**LONG CREEK YOUTH DEVELOPMENT CENTER
ROOF RENOVATIONS**
ADDENDUM #1

February 11, 2015

The following items hereby modify, amend and supersede the plans and specifications dated January 26, 2015 for the above referenced project. The following items are hereby made part of the contract documents by reference and shall be as binding as though inserted in their entirety in the locations specified herein.

AD1-1

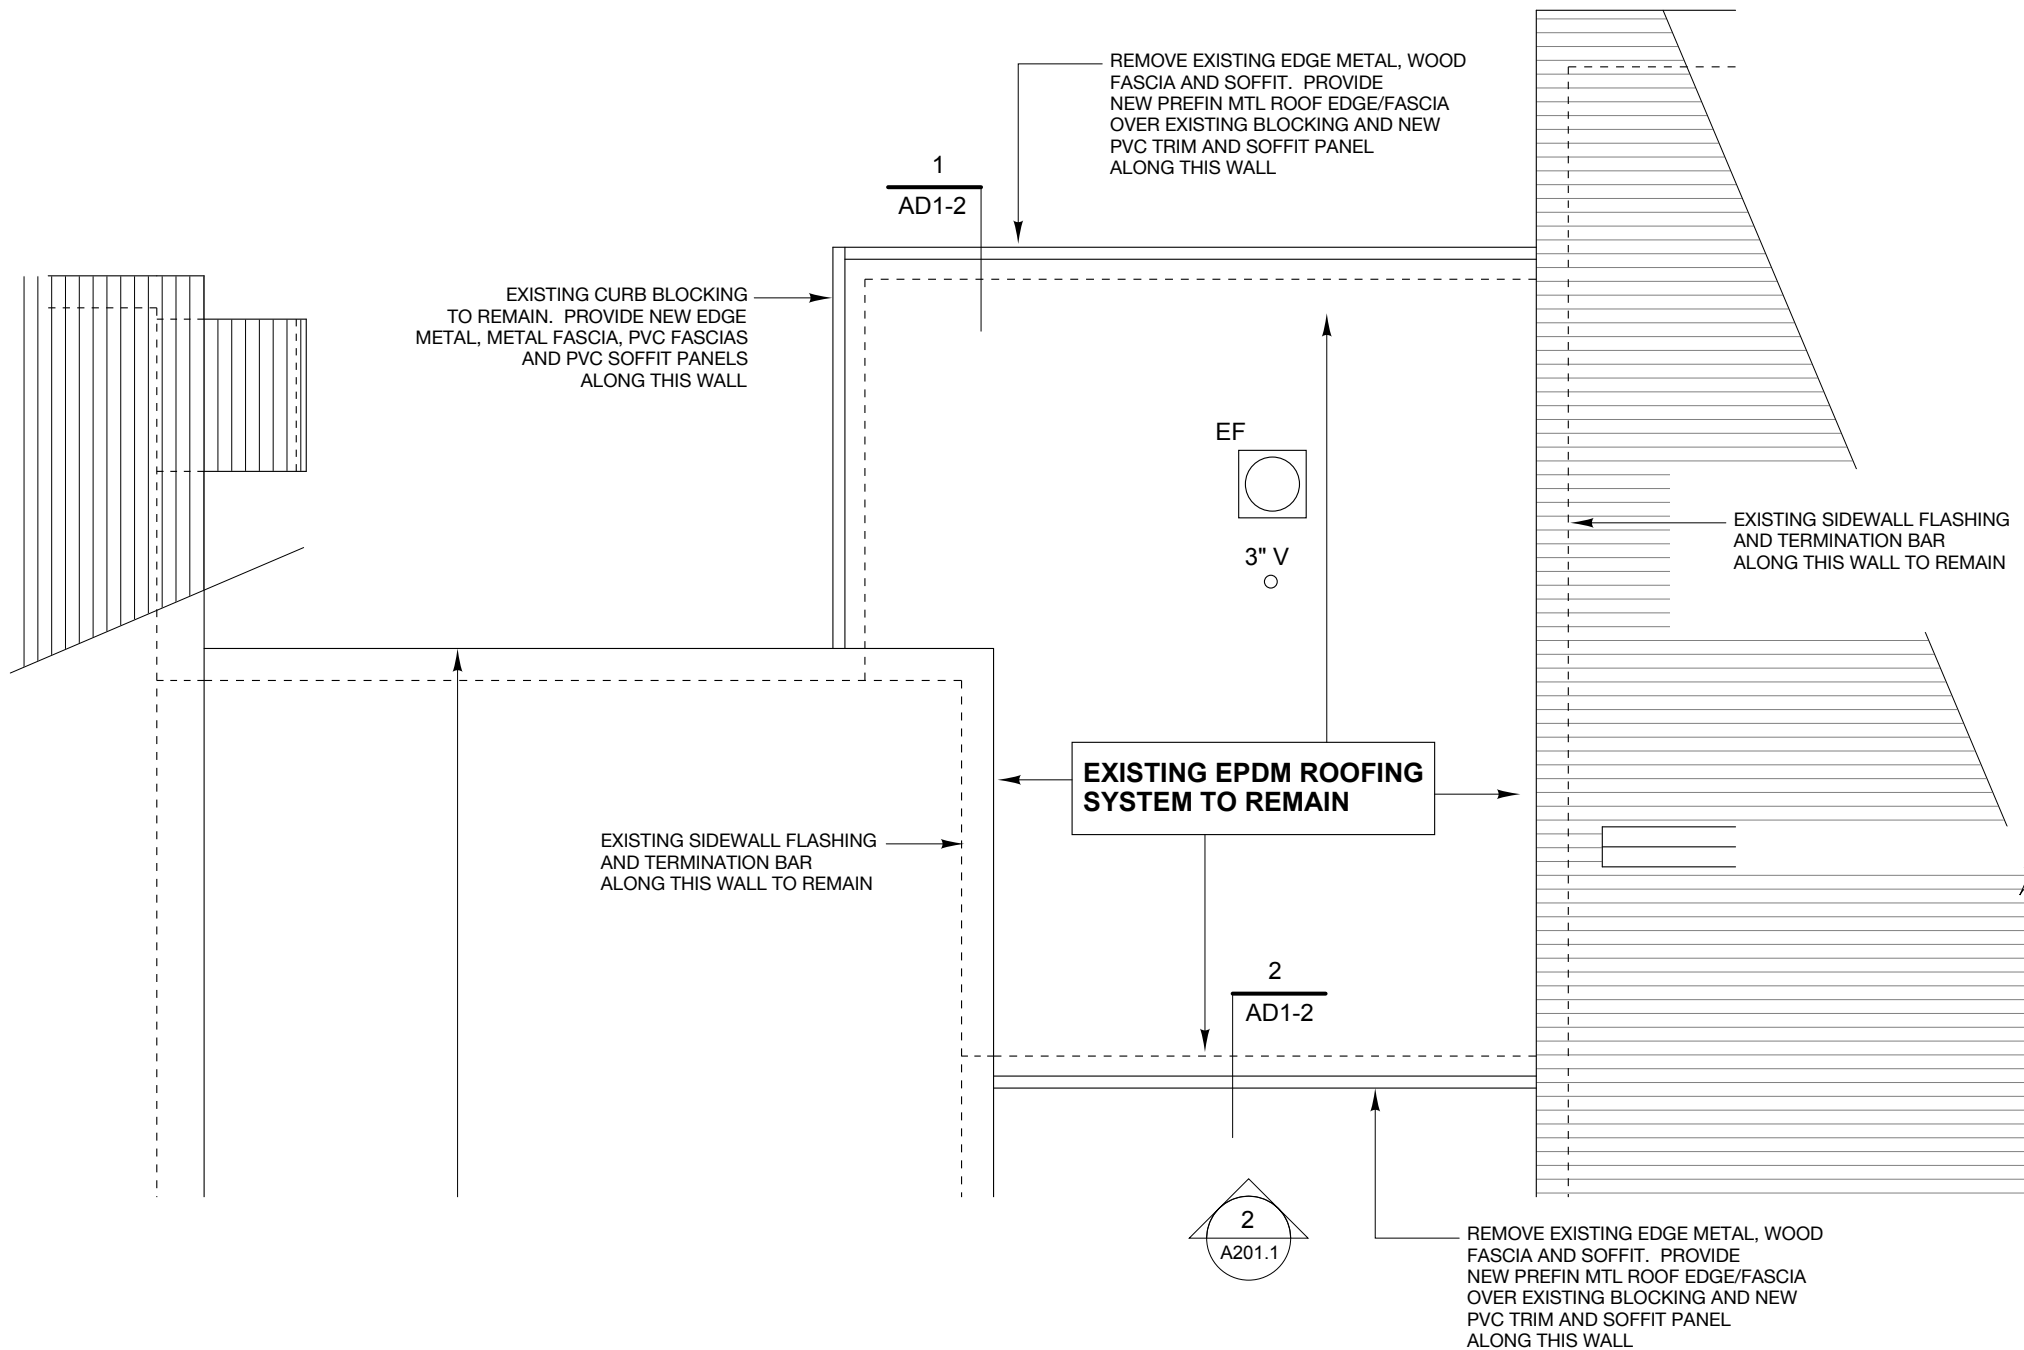
Drawing	Title	Description
1 -	10	A 101.3	Roof Plan	At the low roof with existing EPDM roofing, delete removal and replacement of roofing system and sidewall flashing at adjacent brick walls. The existing system shall remain. Existing edge metal at roof overhangs shall be replaced. Existing wood trim and soffits shall be replaced with PVC trim and painted. Rafter outlook bays shall be blocked and insulated with rigid insulation. Fascia dimensions will vary from original. See attached sketches.
1 -	11	A 101.3	Roof Plan	See notes on the north and south sloped roofs for information on number of layers of shingles and ACM (Asbestos Containing Materials) information. The north wing indicates asbestos in felts and one of the shingle layers. Provide proper removal and disposal of asbestos materials.
1 -	12	Various		Eave and rake trim and soffit panels shall be painted PVC. Where called out as fiber-cement, delete that note and add "PVC".

1 ROOF EDGE DETAIL
SCALE: 1 1/2" = 1'-0"

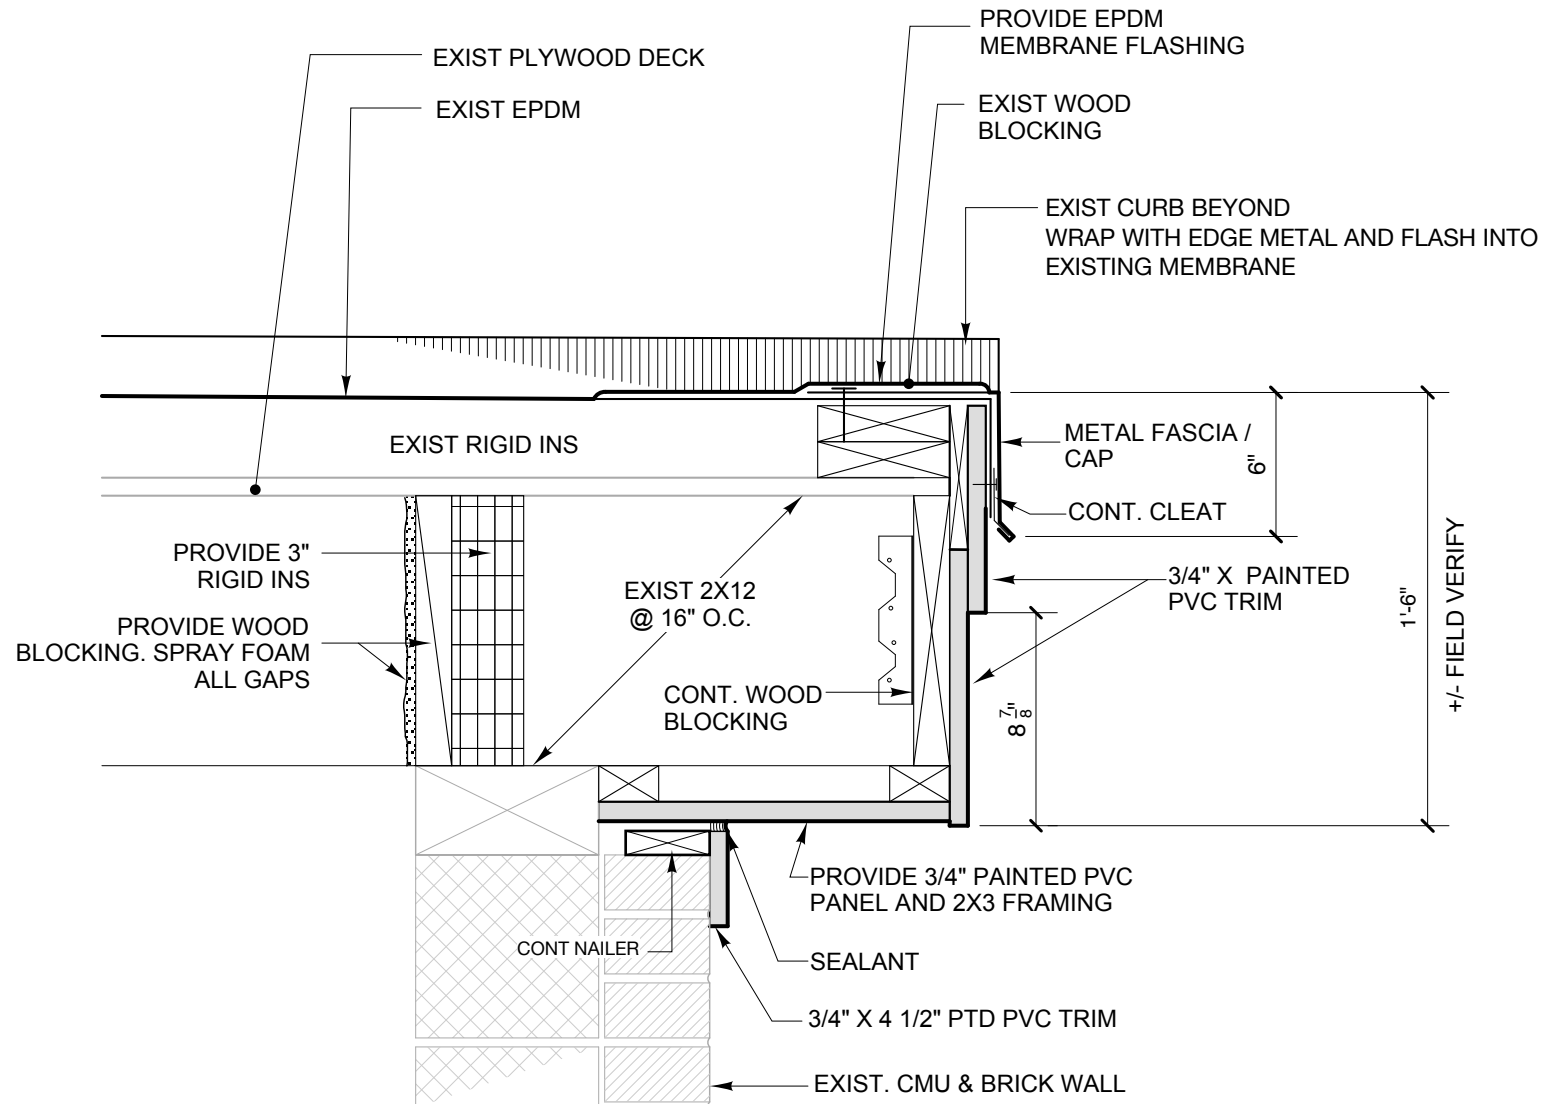
EXISTING EPDM ROOF TO REMAIN

2 ROOF EDGE DETAIL
SCALE: 1 1/2" = 1'-0"

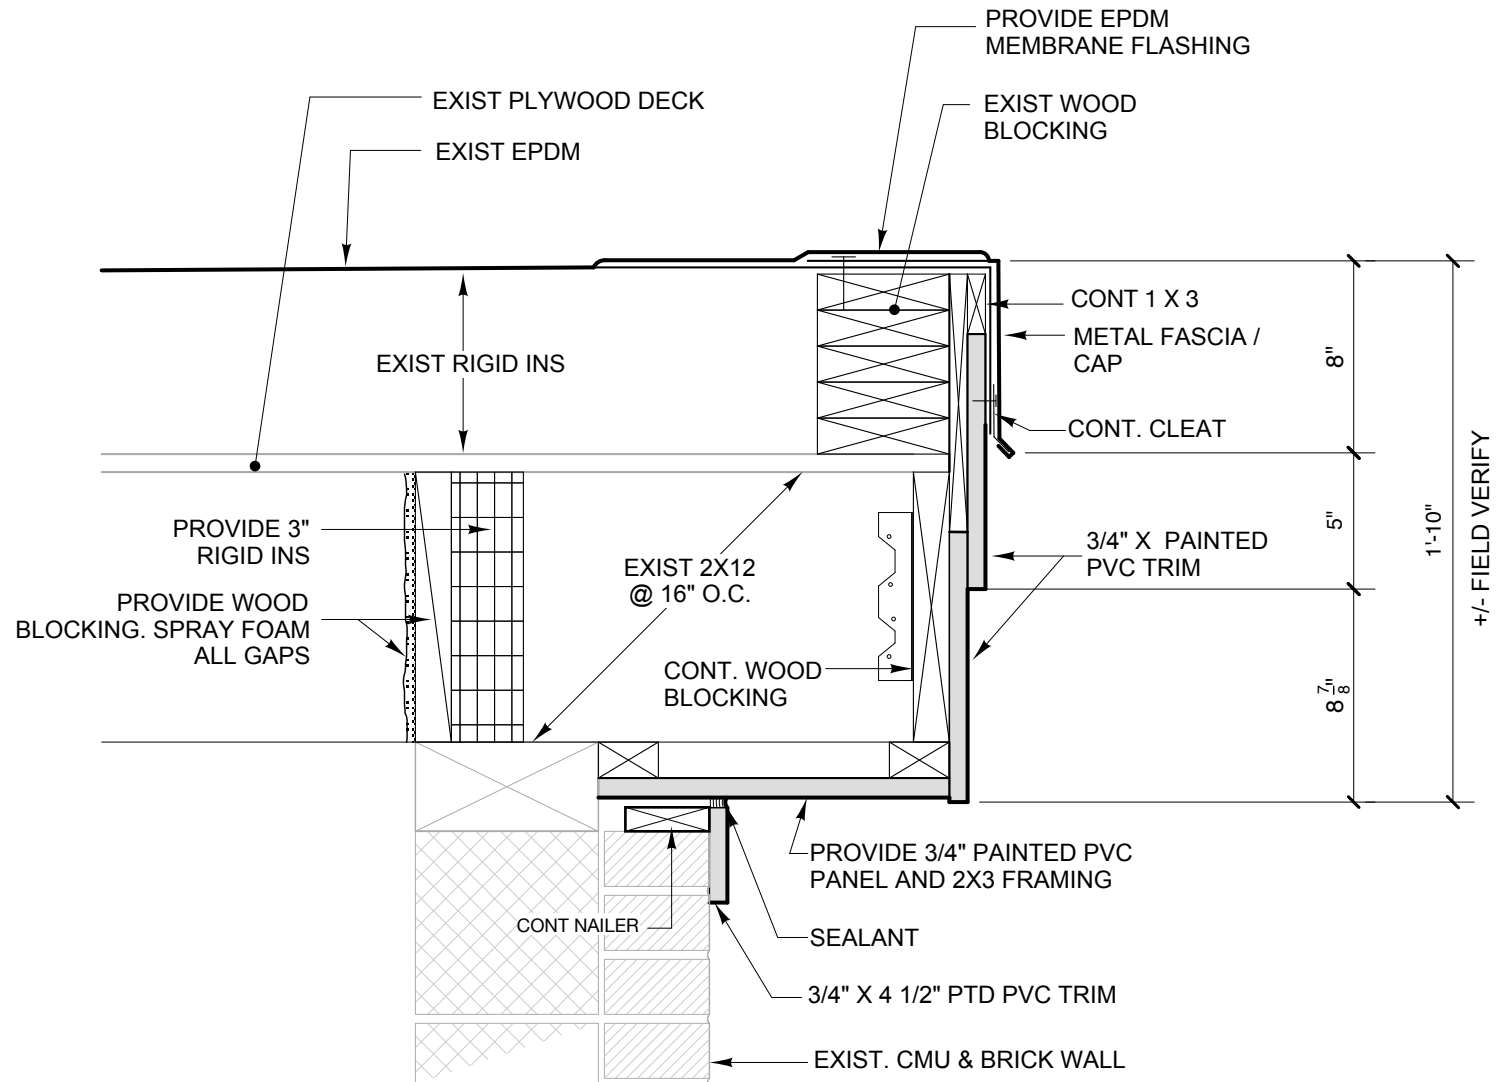
EXISTING EPDM ROOF TO REMAIN
